The Longfellow Bridge - an Opportunity

Current MassDOT plan

Why we should modify the plan for the bridge deck

Longfellow Bridge (does not meet MBTA standards)

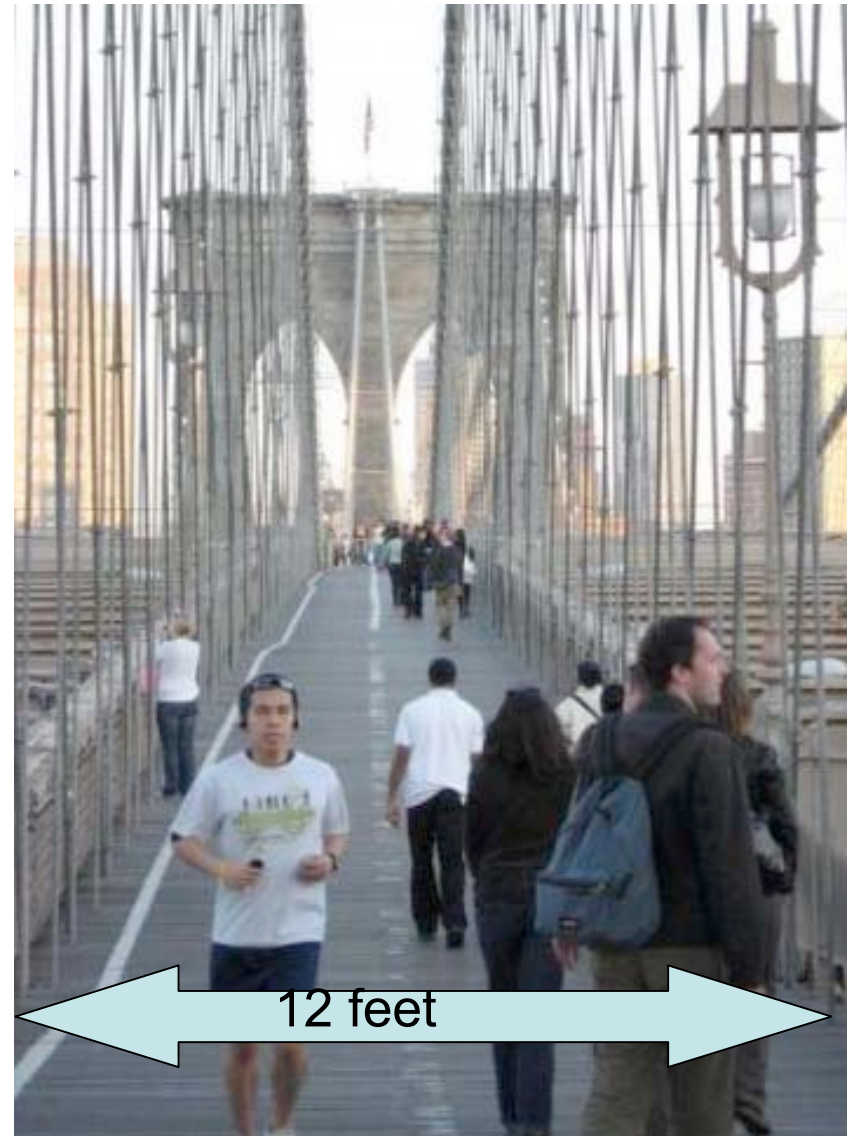
A Better Plan for Transit:

Safety for transit passengers and MBTA employees is upgraded by adding a 2.5 foot emergency evacuation space along the tracks.

St. Paul, MN Freedom Bridge

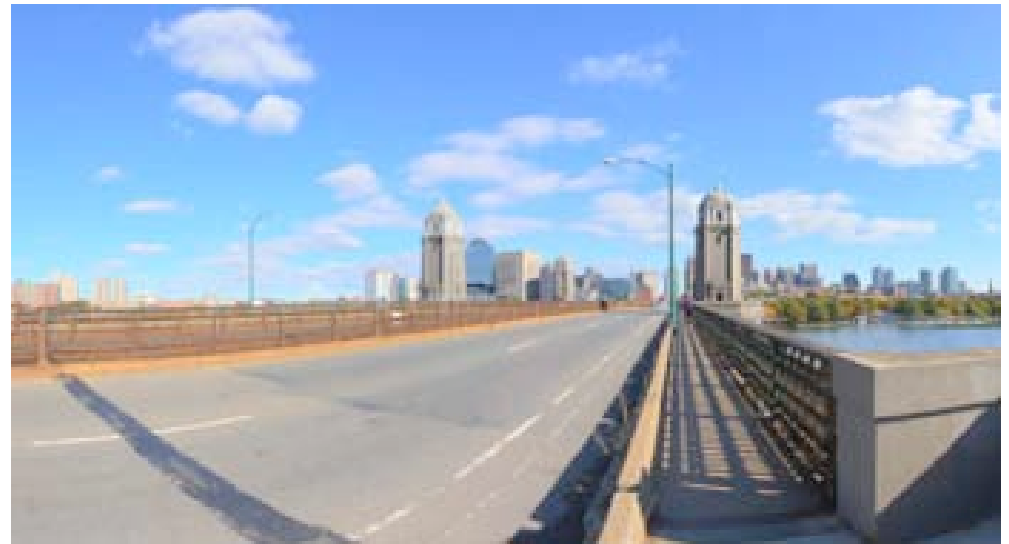
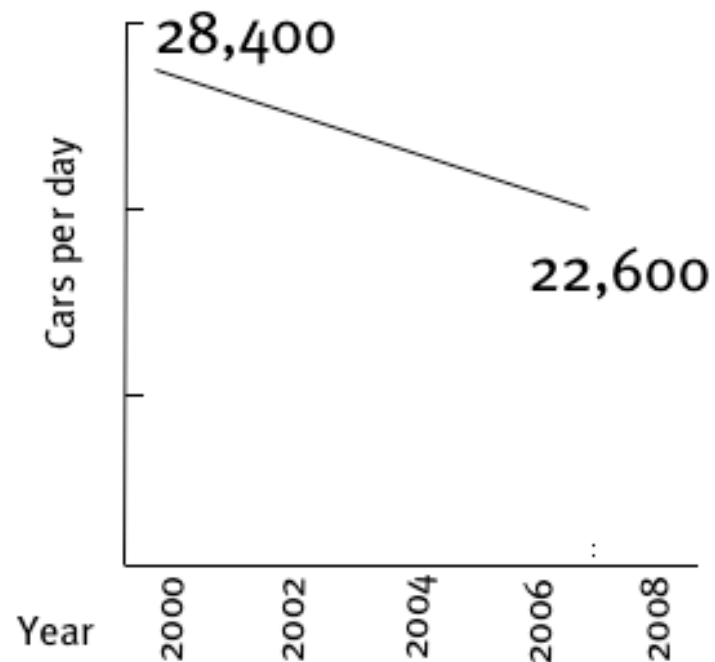
A Better Plan for Lighting Design:

An integrated lighting and crash barrier can be elegant and space-saving.
